# *Town of Brookline*

### **PLANNING BOARD**

To: Brookline Board of Appeals  
From: Brookline Planning Board  
Date: April 14, 2016  
Subject: Expand mudroom, convert portion of basement to living area, and construct a permanent breezeway connecting dwelling to detached garage  
Location: 355 Buckminster Road

Atlas Sheet:	58	Case #:	2016-0013
Block:	258	Zoning:	S-25
Lot:	03-04	Lot Area (s.f.):	±37,310 sf

PLAN OF LAND IN  
 BROOKLINE, MA  
 355 BUCKMINSTER ROAD  
 PROPOSED ADDITIONS

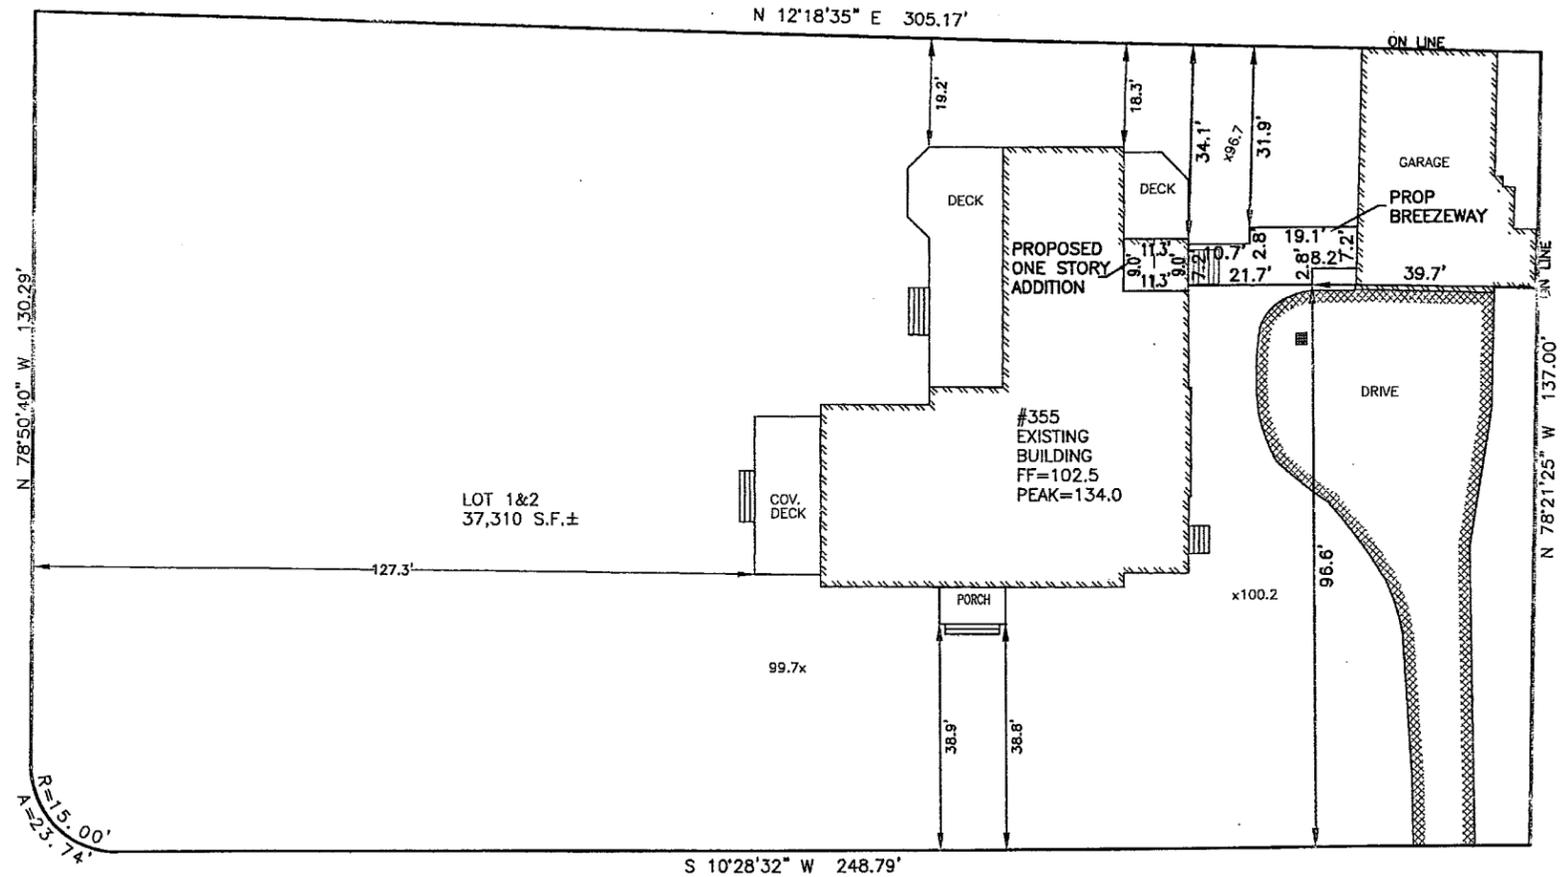
**Therefore, the Planning Board recommends approval of the site plan by professional land surveyor Bruce Bradford of Everett M. Brooks Co. dated 4/8/2016 and the floor plans and elevations prepared by registered architect Frederick Soule of Combined Energy Systems, Inc. dated 4/8/2016, subject to the following conditions:**

**Exterior Elevations  
 - New Addition -  
 Phase 2**

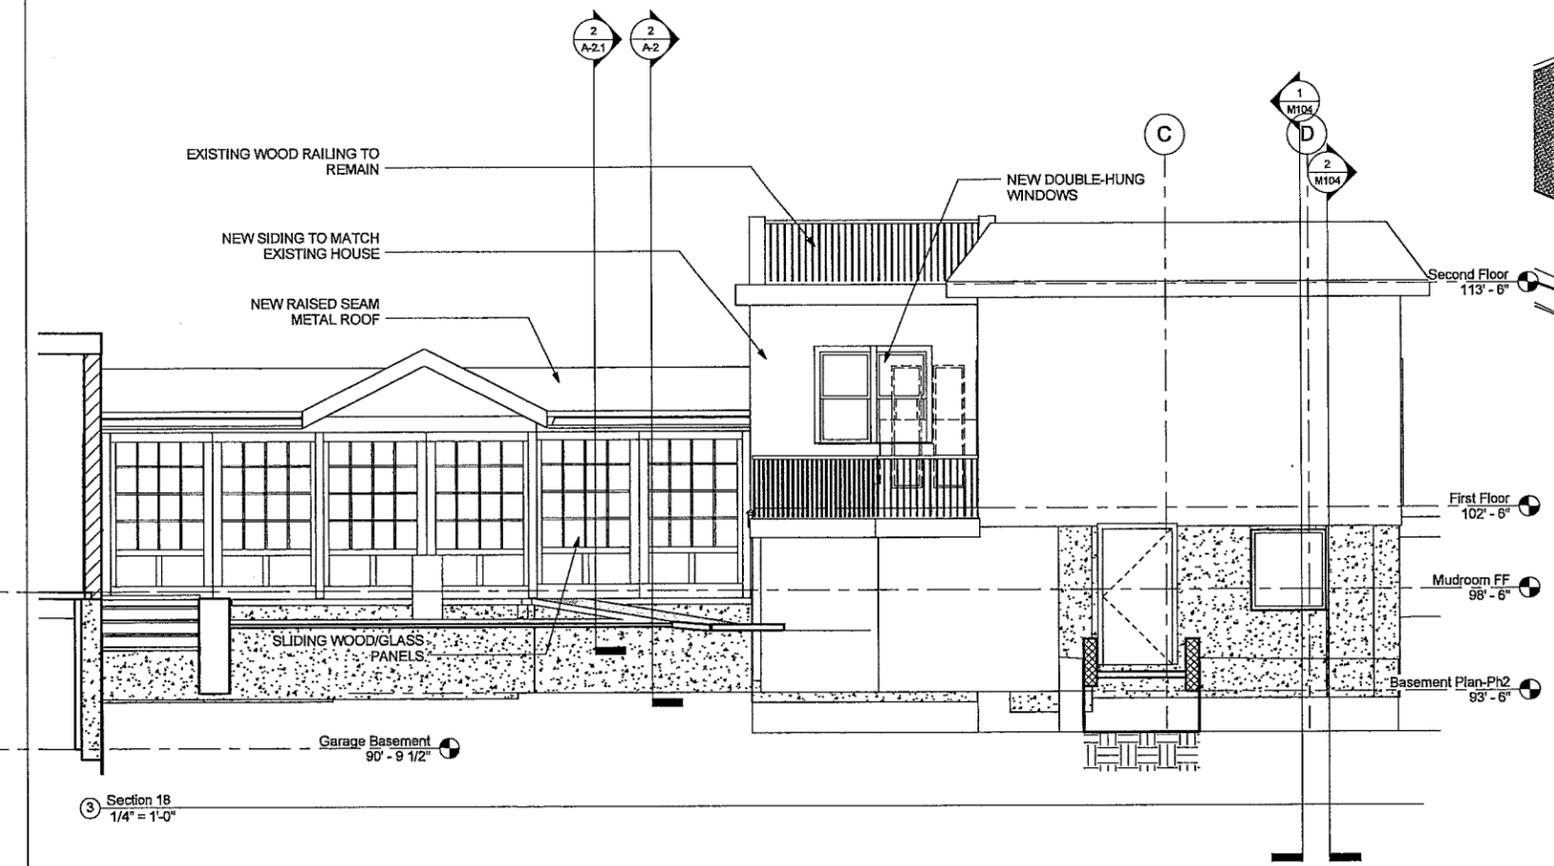
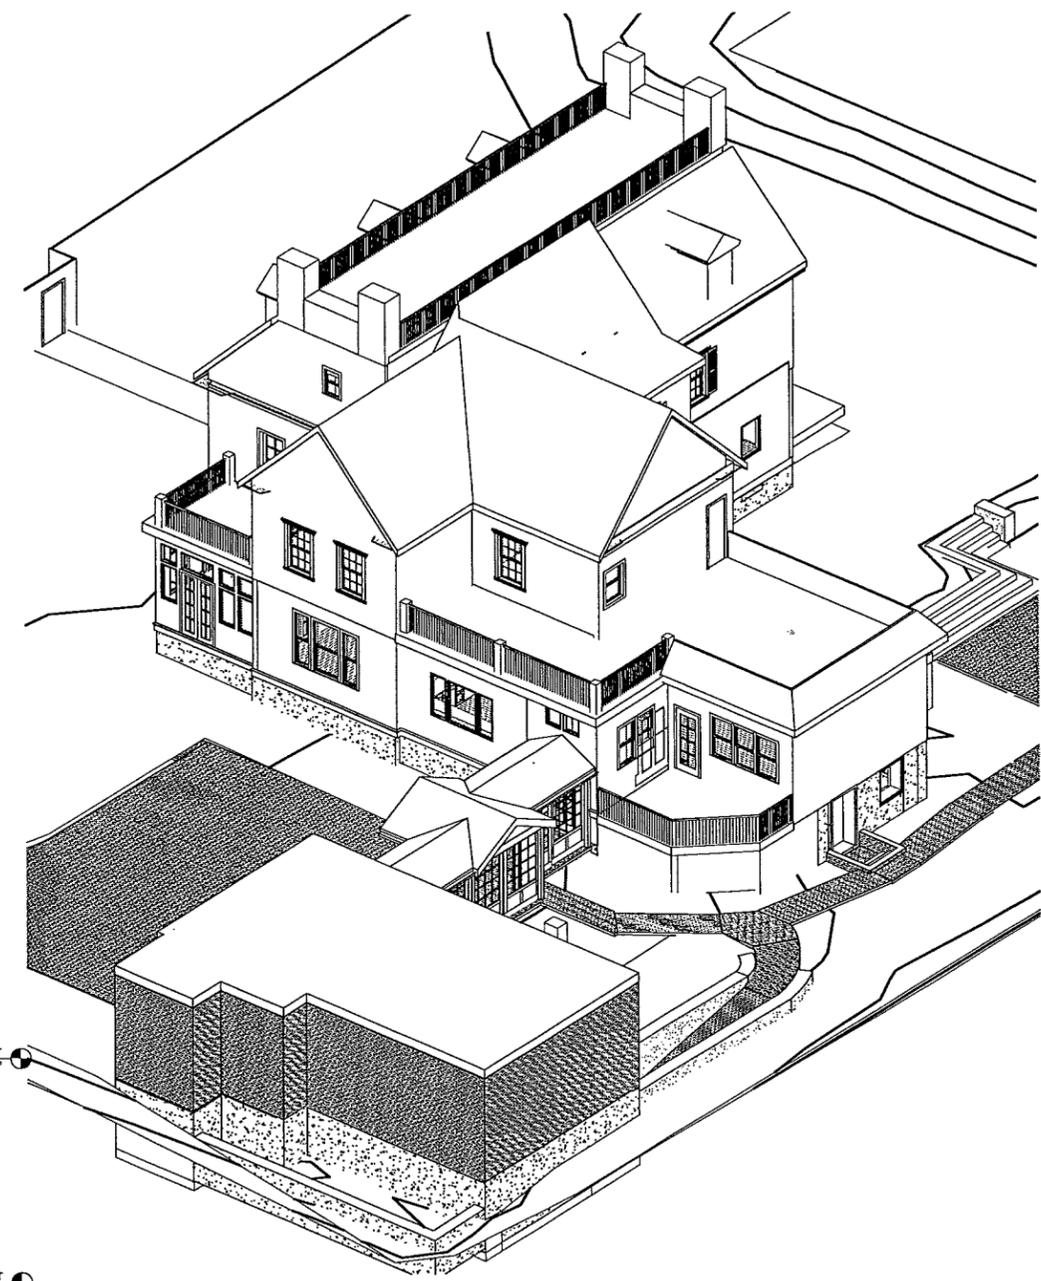
The modest addition on this oversized lot is proposed in the side-rear yard and would not impact the Buckminster Road streetscape. Landscaping in the abutting rear yard is heavy, and the applicant’s existing garage in the side yard would align with the addition and screen it from view. The breezeway would consist of sliding glass panels; the use of glass and the option to slide the panels open are two qualities that reduce the visual massing of this feature.

The applicant proposes enhanced landscaping as a counterbalancing amenity. The addition and the landscaping are well-designed. The breezeway is also thoughtfully designed and does not detract from the architectural character of the main structure. The proposal would meet the open space requirements, as well.
